TECHNICAL BULLETIN

407-19-128

MODEL AFFECTED: 407

SUBJECT: TAILBOOM 407-030-801-219, MODIFICATION OF

Figure 1 - Tailboom Assembly (Sheet 1 of 4)

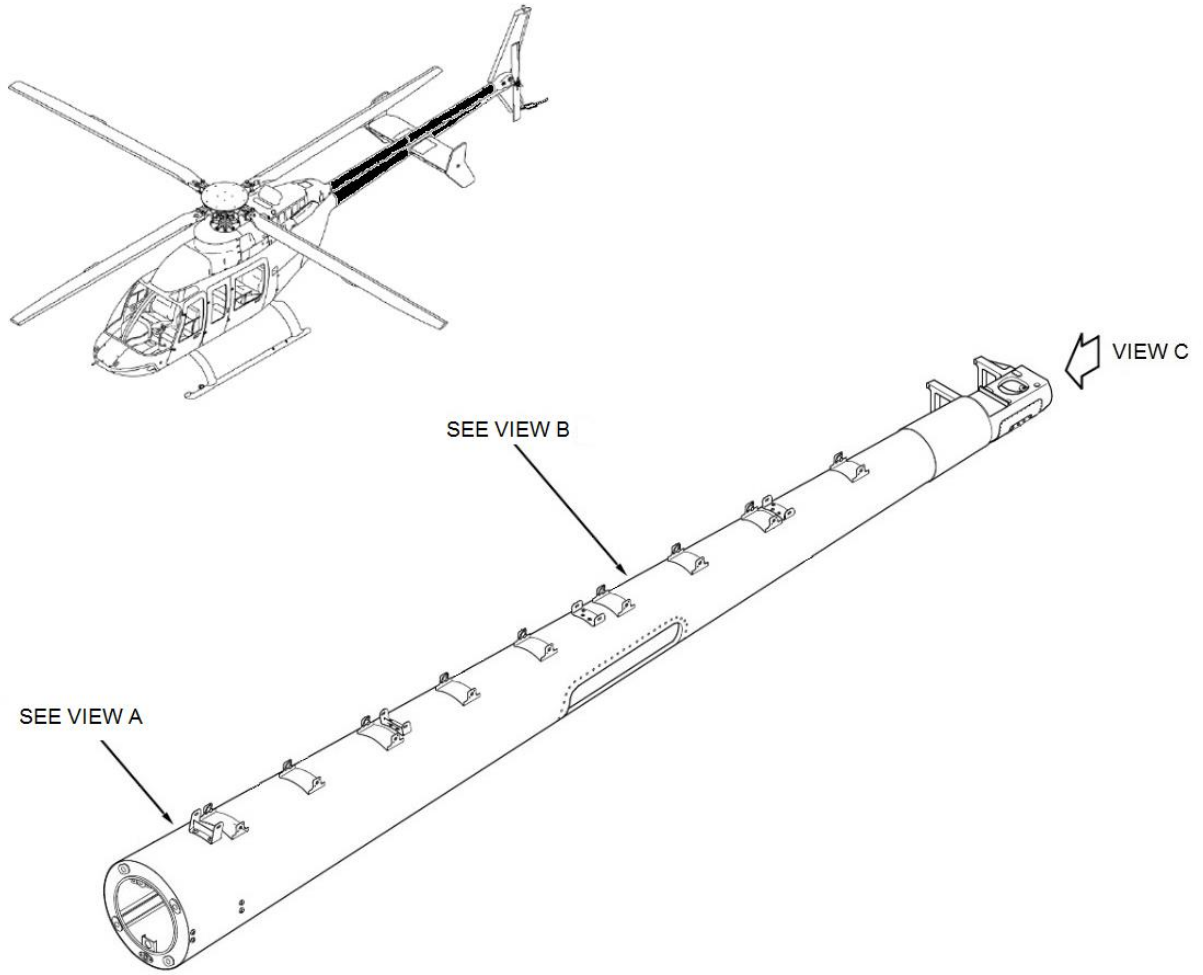
1. Prepare the helicopter for maintenance.
 - a. Gain access to bulkhead BS 42.59 (1, Figure 1), bulkhead BS 120.75 (2) and aft of tail rotor gearbox support (3) by removing tailboom, horizontal stabilizer and tail rotor gearbox fairing (BHT-407-MM-5, Chapter 53).
2. Magnetometer support installation.
 - a. Locate magnetometer support (4, Figure 1) on bulkhead (1) from existing tooling holes.
 - b. Mark area of contact of magnetometer support (4) to bulkhead (1).

- e. Remove aluminum foil tape (C-439).
 - f. Locate magnetometer support (4) on bulkhead (1) from existing tooling holes, align magnetometer support (4) and frame tooling holes and transfer quantity 10 holes from magnetometer support (4) to bulkhead (1).

- i. Install magnetometer support (4) to bulkhead (1) using rivets (7) in wet sealant (C-251) (BHT-ALL-SRM, Chapter 3).
 - j. Perform bond resistance test between magnetometer support (4) and bulkhead (1) (BHT-ELEC-SPM, Chapter 8). Make sure bonding resistance meets electrical bond Class R-II.

Figure 1 - Tailboom Assembly (Sheet 2 of 4)

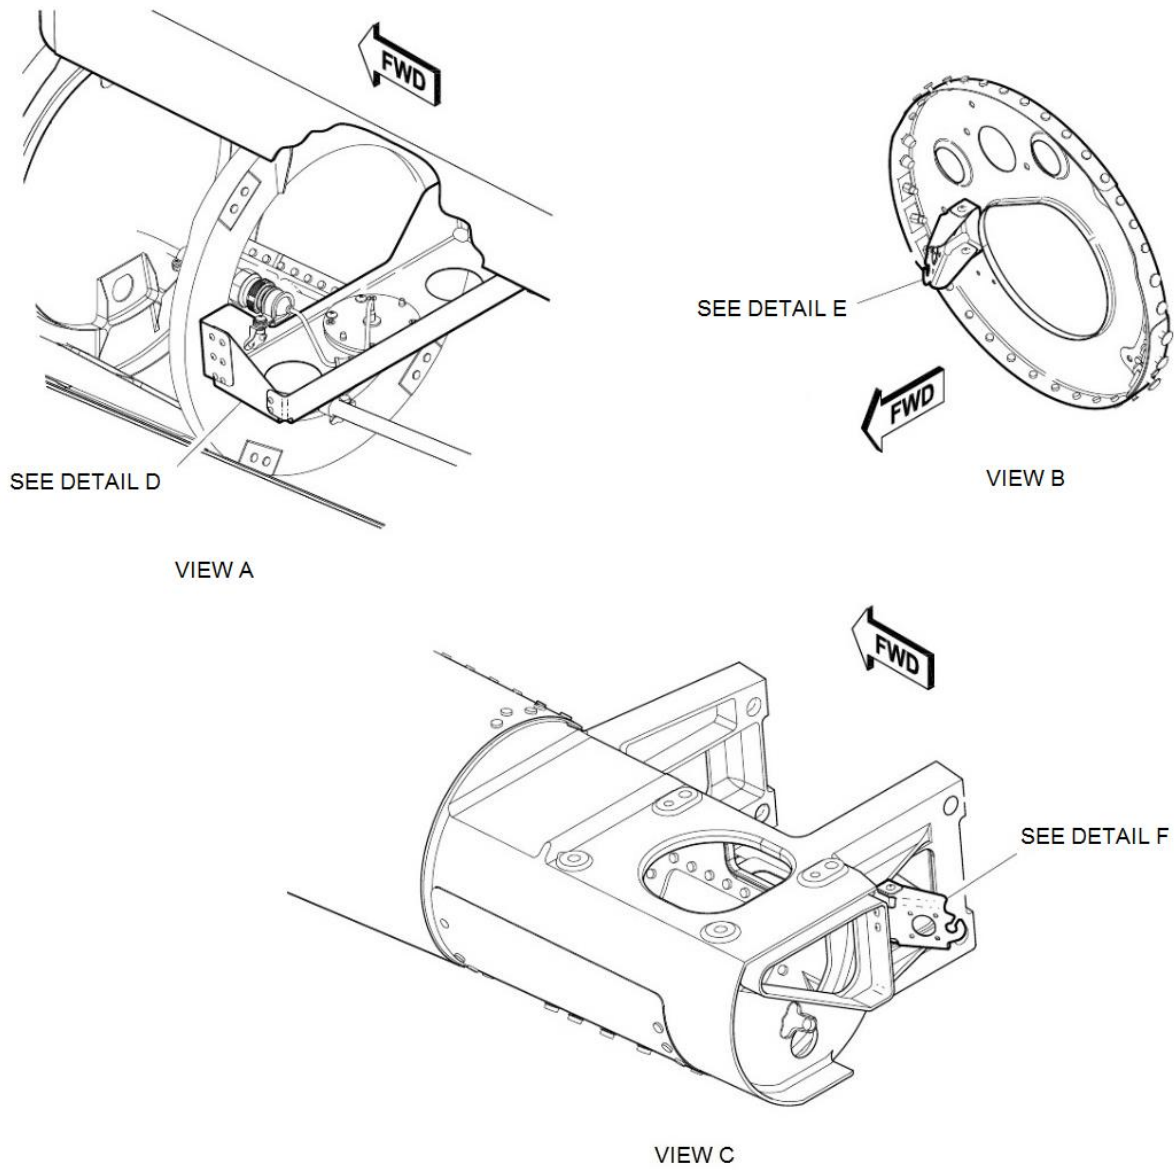
3. Horizontal stabilizer connector bracket installation.
- a. Locate connector bracket (6, Figure 1) on bulkhead BS 120.75 (2) from existing tooling holes in bulkhead (2) and pilot holes in bracket (6).

- j. Perform bond resistance test between connector bracket (6) and bulkhead (2) (BHT-ELEC-SPM, Chapter 8). Make sure bonding resistance meets electrical bond Class R-II.

- k. Seal edges of connector bracket (6) (BHT-ELEC-SPM, Chapter 8) using sealant (C-251).
 - l. Remove terminal board (8), insulator strip (9), screws (10), washers (11), nuts (12), ground stud screw (13), lock washer (14), washer (15), nut (16), and decals (17 and 19).

Figure 1 - Tailboom Assembly (Sheet 3 of 4)

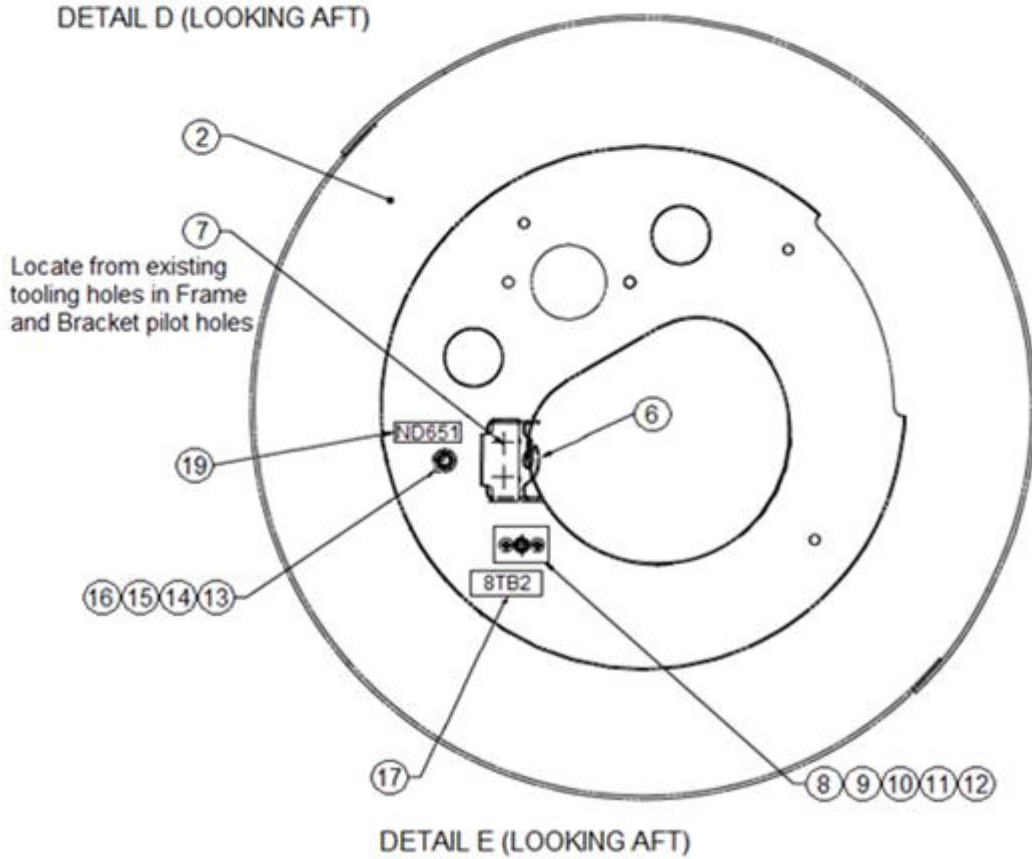
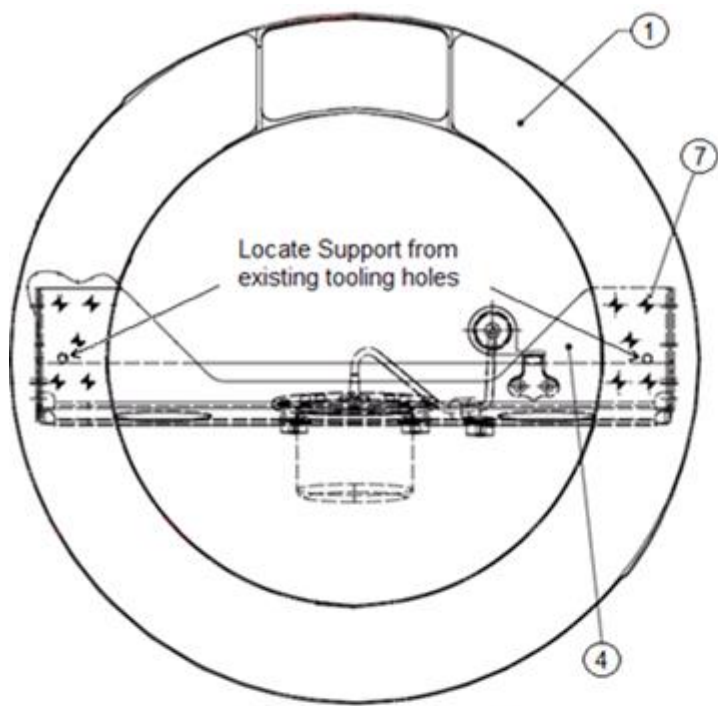
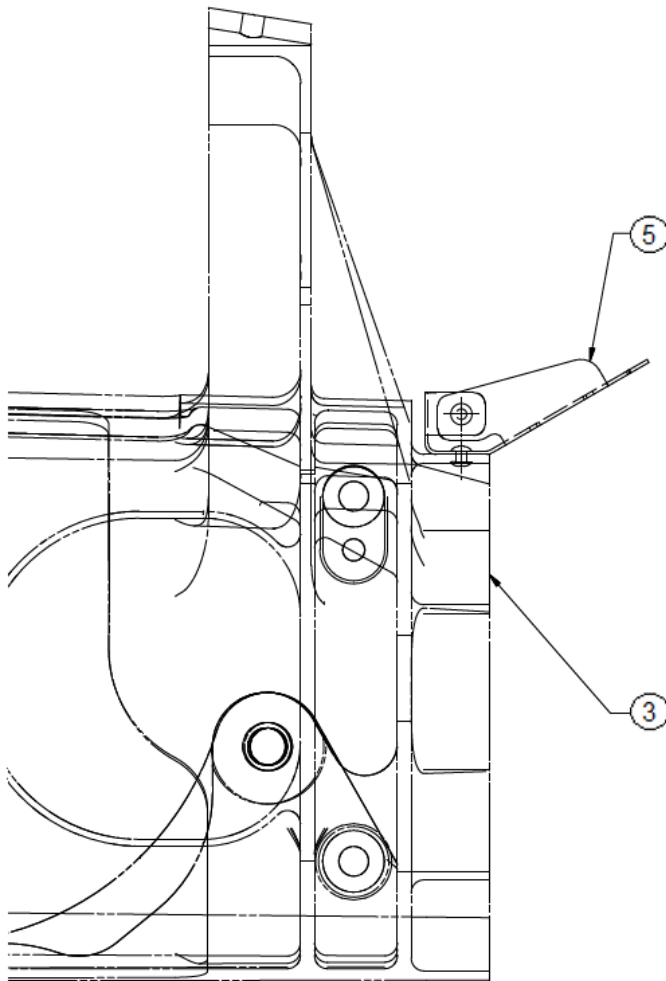
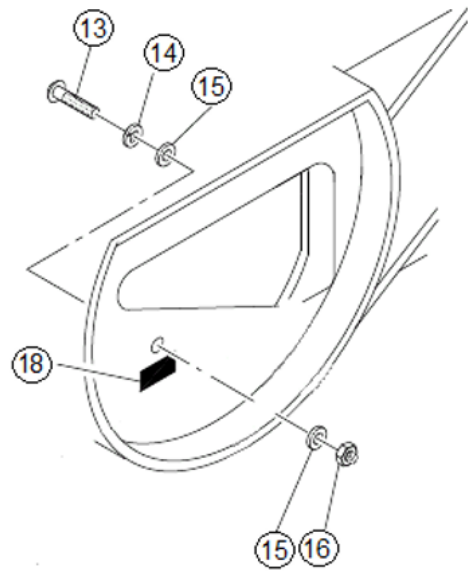
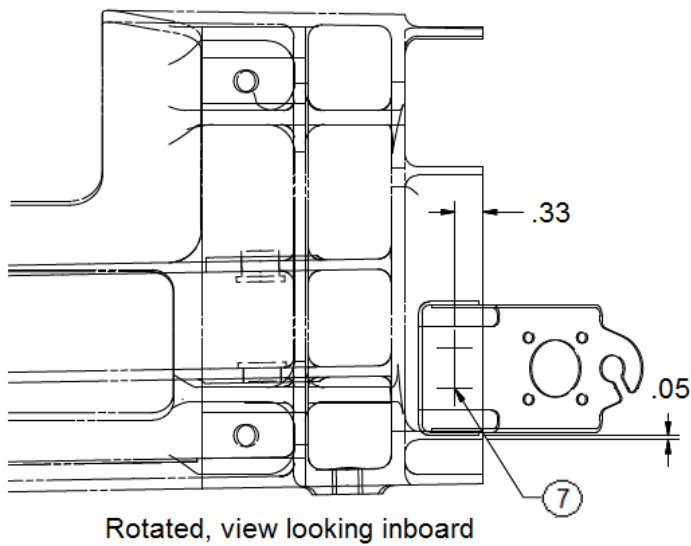
- m. Apply epoxy primer (C-246) to all remaining exposed structure and rivets (7).
4. Tail rotor gearbox connector bracket installation.
- a. Locate connector bracket (5, Figure 1) on aft side of tail rotor gearbox support casting (3) approximately 0.05 inch (1.27 mm) below corner of casting (3) and with the rivet pilot holes centered 0.33 inch (8.38 mm) from the edge of the casting (3) flange web.

- i. Install connector bracket (5) to tail rotor gearbox casting (3) using rivets (7) in wet sealant (C-251) (BHT-ALL-SRM, Chapter 3).

- j. Perform bond resistance test between connector bracket (5) and tail rotor gearbox casting (3) (BHT-ELEC-SPM, Chapter 8). Make sure bonding resistance meets electrical bond Class R-II.
- k. Seal edges of connector bracket (5) (BHT-ELEC-SPM, Chapter 8) using sealant (C-251).
- l. Remove ground stud screw (13), lock washer (14), washers (15), nut (16) and decal (18).
- m. Apply epoxy primer (C-246) to all remaining exposed structure and rivets (7).
